# MECKLENBURG COUNTY
# DEPARTMENT OF ENVIRONMENTAL HEALTH

## APPLICATION FOR SOIL INVESTIGATION

SITE EVALUATION

RE: Property located at Brookfield Place

**See Diagram on Back (includes: soil areas, property lines, roads, streams, gullies, wet areas, fill areas, wells, water bodies, slopes)

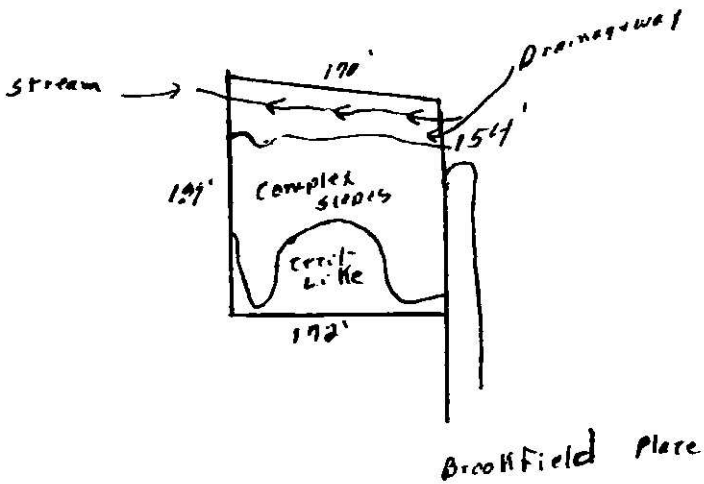
| FACTORS | AREA 1 | AREA 2 | AREA 3 | AREA 4 |
|---|---|---|---|---|
| 1. SLOPE (%) | S / PS 5-15% / U | S / PS complex slopes / U | S / PS 2-8% / U | S / PS / U |
| 2. SOIL TEXTURE (12-36 inches) Sandy, Loamy, Clayey (Note 2-1 Clay) | S / PS clay / U | S / PS clay / U | S / PS clay loam / U | S / PS / U |
| 4. SOIL DEPTH (inches) | S / PS 36-40" / U | S / PS <36" / U | S / PS 30-40" / U | S / PS / U |
| 6. SOIL DRAINAGE/GROUNDWATER (external and internal) | S / PS >40 To ground water / U | S / PS Eroded Areas / U channel bought | S / PS seasonal water table 24-36" / U | S / PS / U |
| 9. SITE CLASSIFICATION | unsuitable | unsuitable | unsuitable | |

Stream
170'
Drainageway
154'
Complex slopes
Cecil-Like
172'
Brookfield Place
